ADDENDUM #4

07/24/2014

**TO PLANS AND SPECIFICATIONS FOR
RENOVATION AND ADDITION TO
FT. SAM HOUSTON ELEMENTARY SCHOOL
&
RENOVATION AT COLE HIGH SCHOOL**
Ft. Sam Houston
San Antonio, TX

9

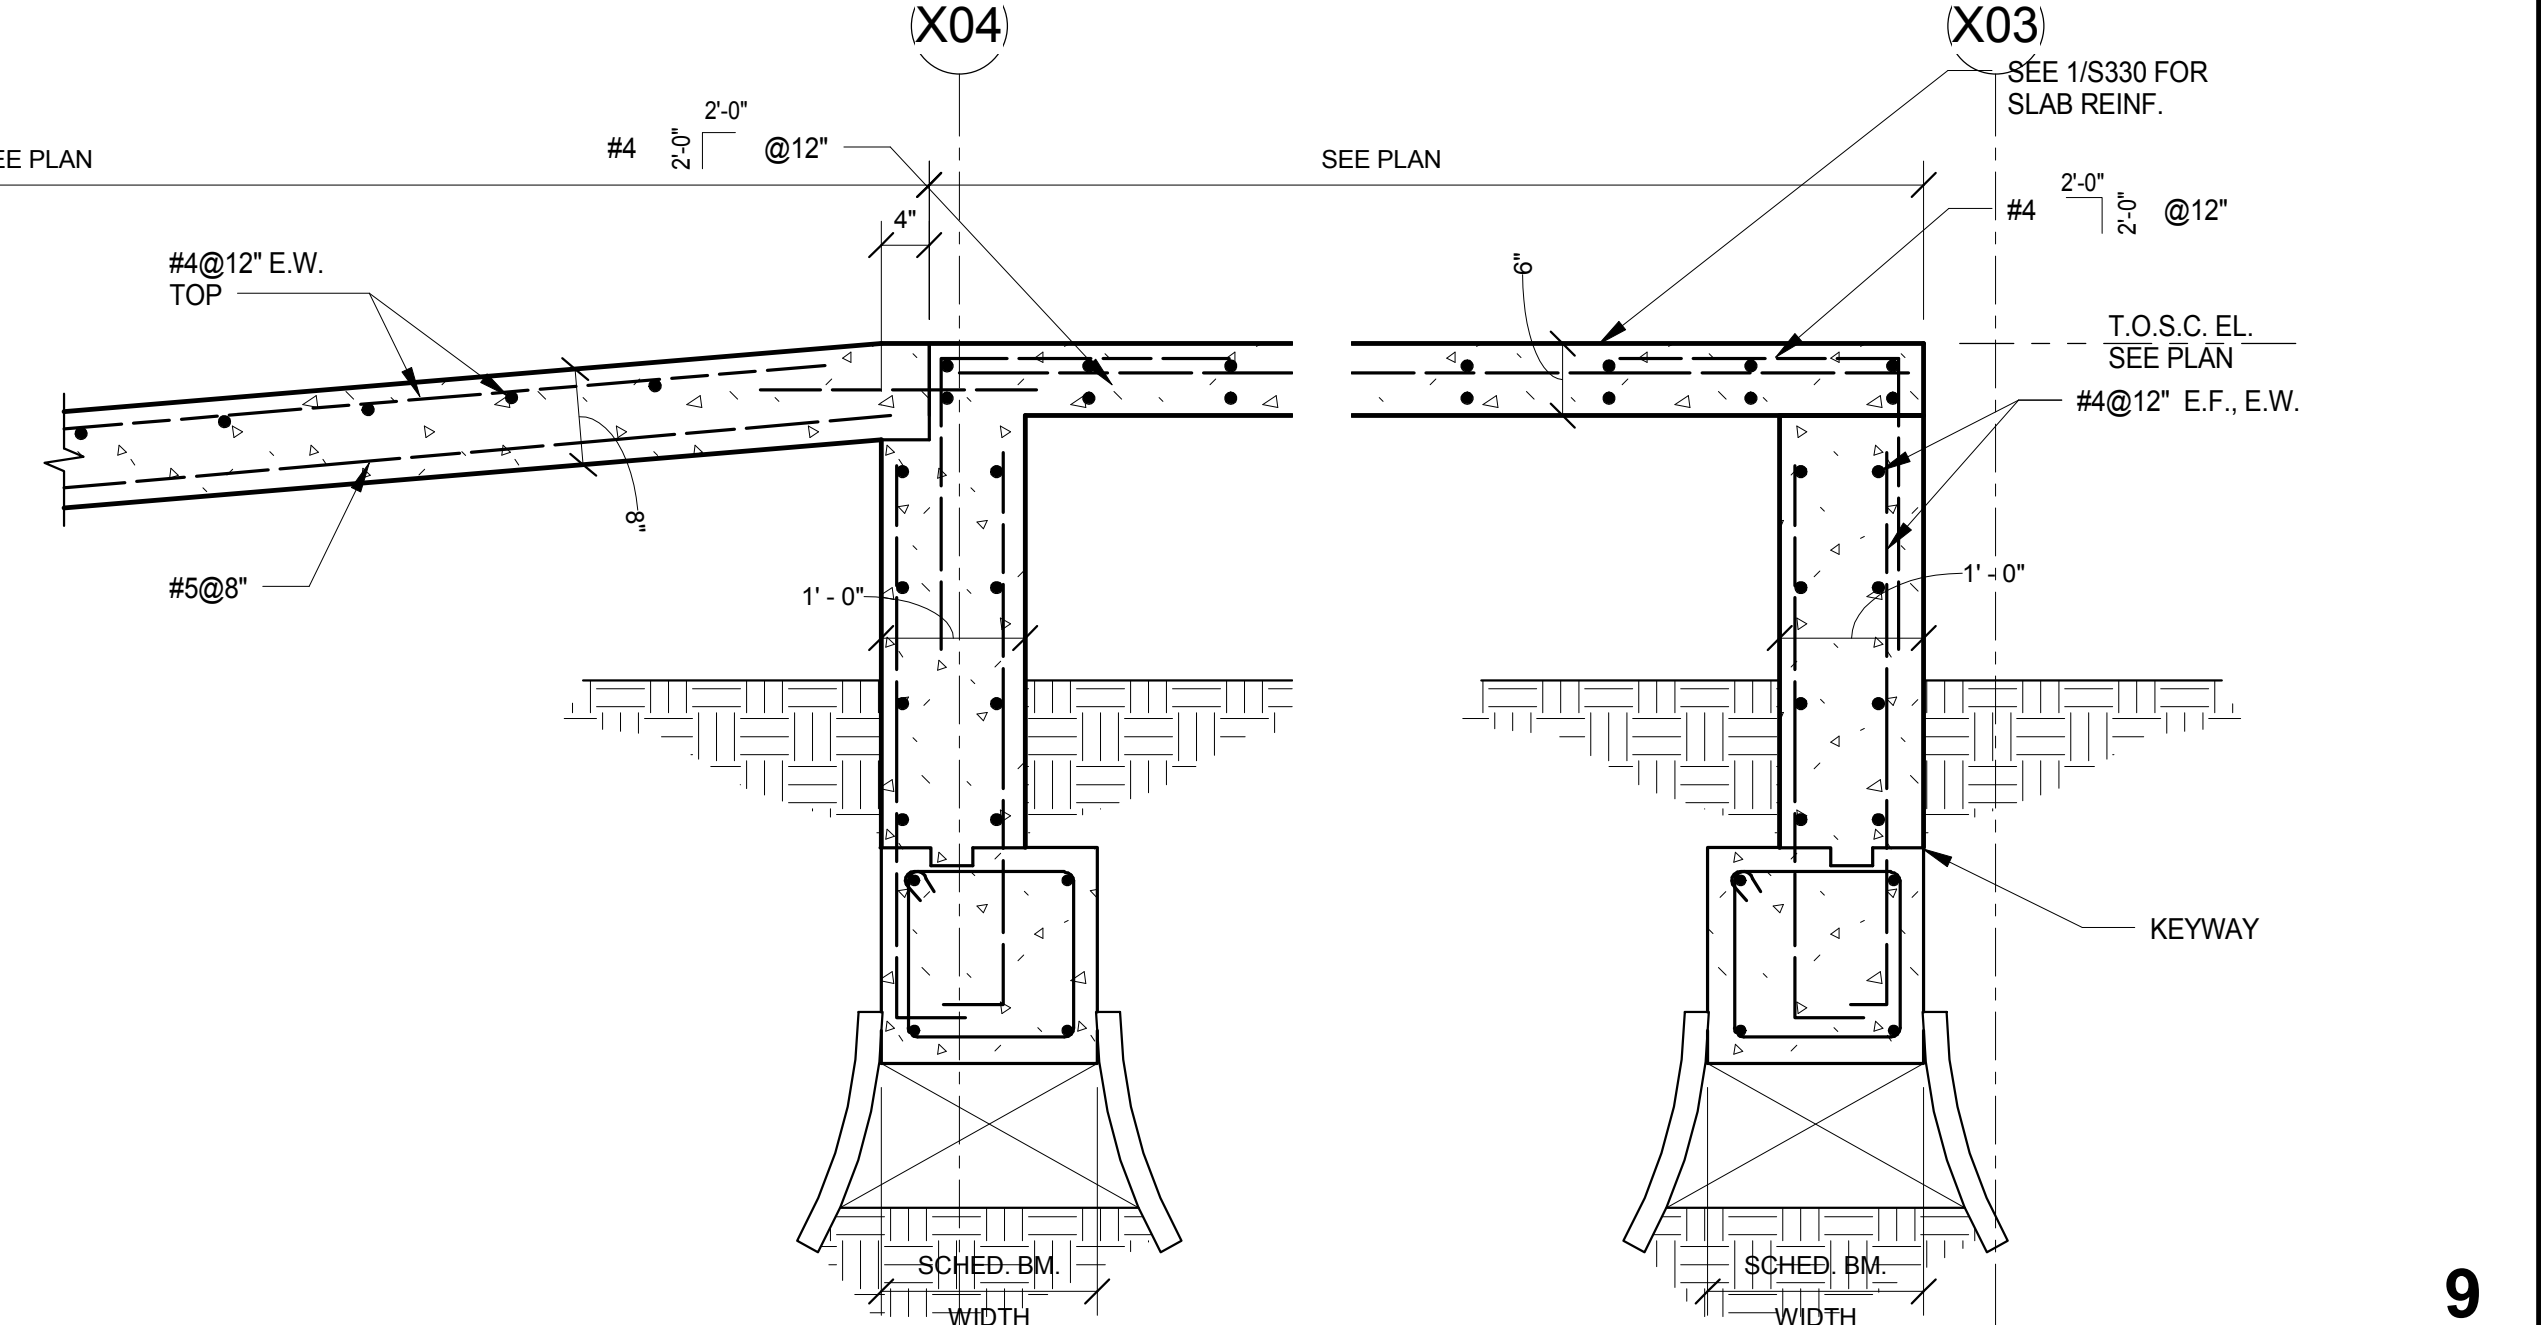
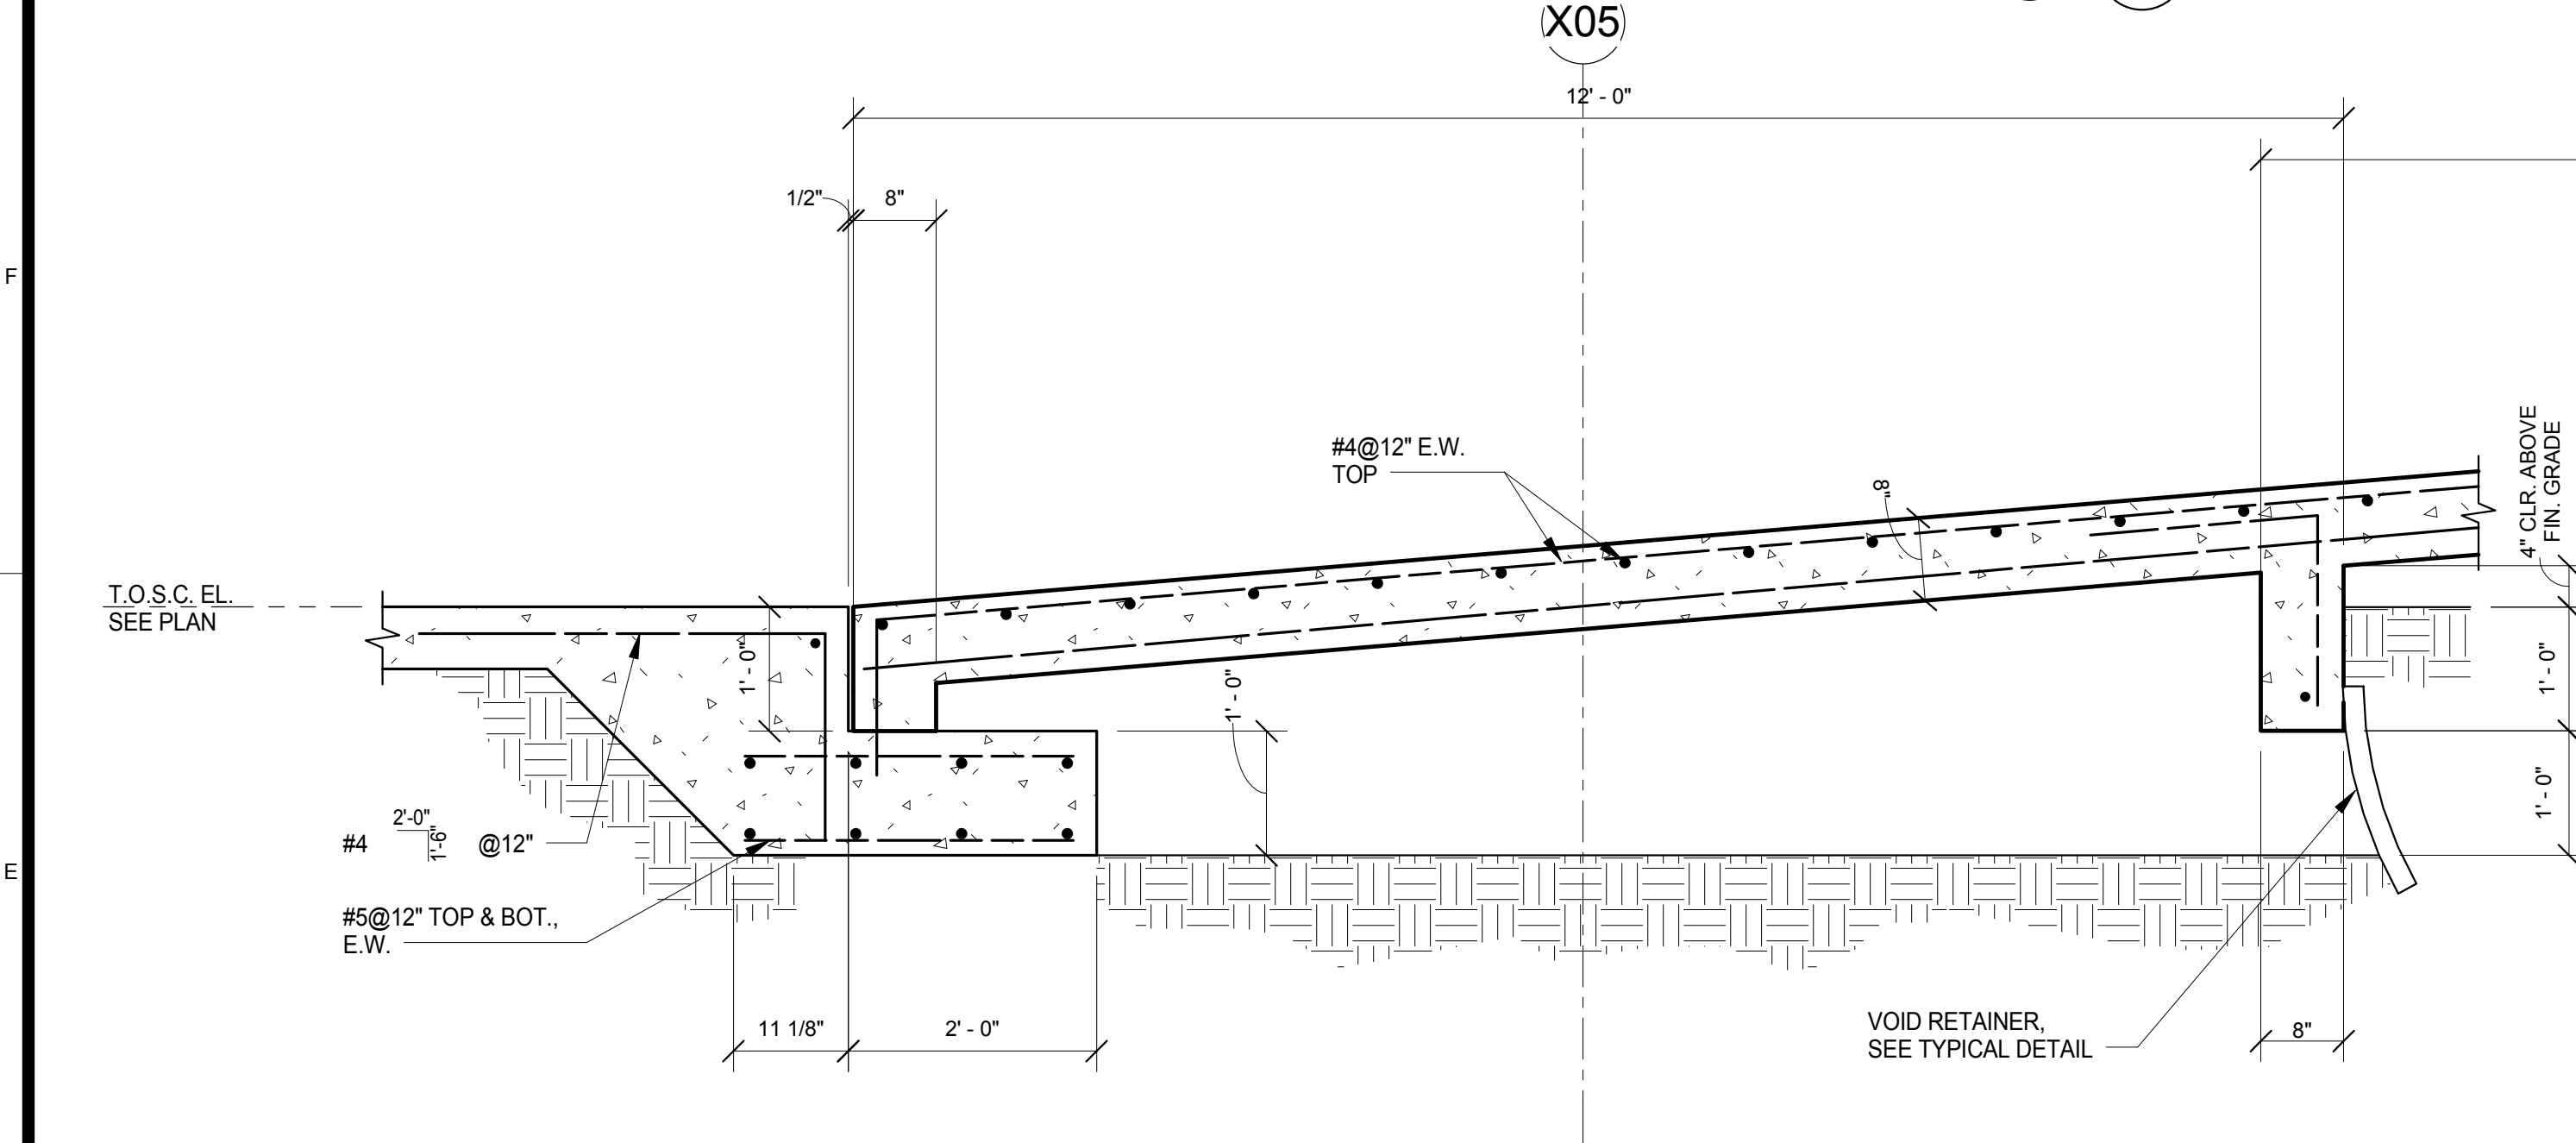
- A. Sheet S300:
 - a. See revised sheet for changes to typical pier detail and pier schedule.
- B. Sheet S310
 - a. See revised sheet for clarifications to grade beam reinforcing.
